UNITED STATES
DEPARTMENT OF THE INTERIOR
BUREAU OF LAND MANAGEMENTFORM APPROVED
OMB NO. 1004-0137
Expires: January 31, 2018**SUNDRY NOTICES AND REPORTS ON WELLS**
*Do not use this form for proposals to drill or to re-enter an abandoned well. Use form 3160-3 (APD) for such proposals.*Case Serial No.
NMNM02965A

BARLOW 34 FED COM 712H

EOG Resources requests an amendment to our approved APD for this well to reflect a change in BHL as per attached.

Change BHL to: 2540'FSL & 1390'FEL NWSE 27-26S-33E

Lea County, New Mexico
Proposed Wellbore
Revised 7/11/18
API: 30-025-44391

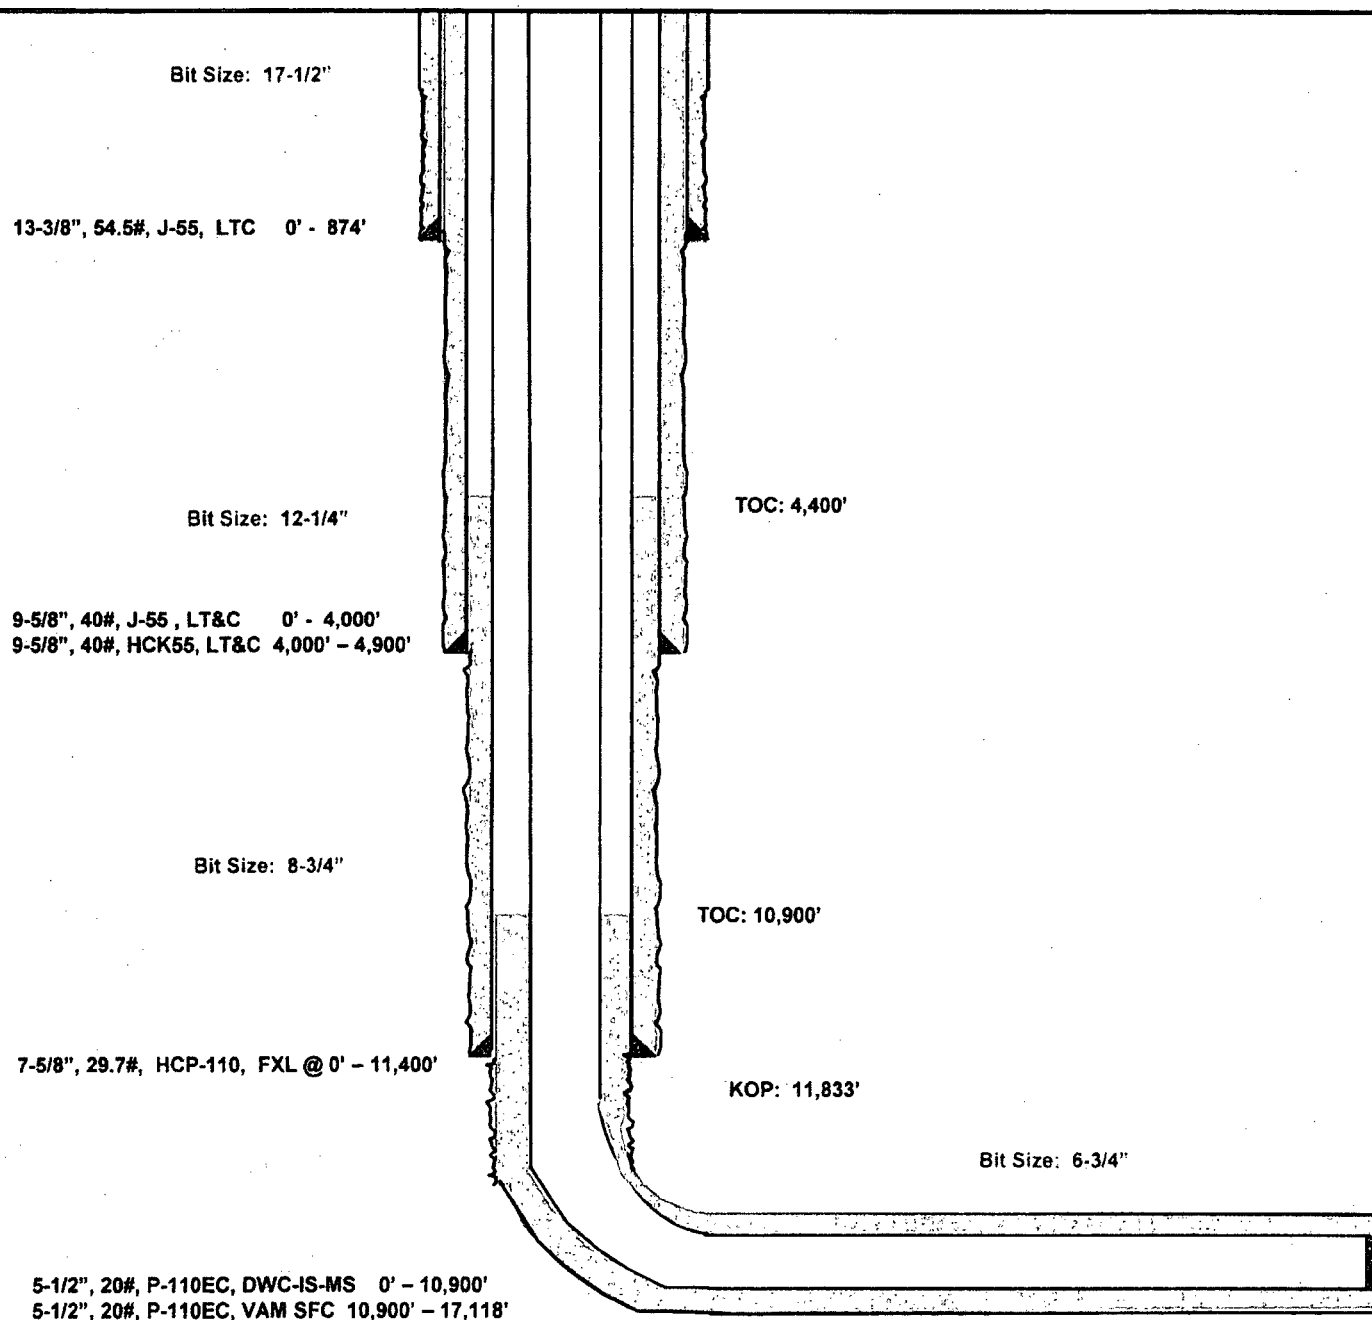
Lateral: 17,118' MD, 12,319' TVD
Upper Most Perf:
100' FSL & 1390' FEL Sec. 34
Lower Most Perf:
2540' FSL & 1390' FEL Sec. 27
BH Location: 2540' FSL & 1390' FEL
Section 27
T-26-S, R-33-E
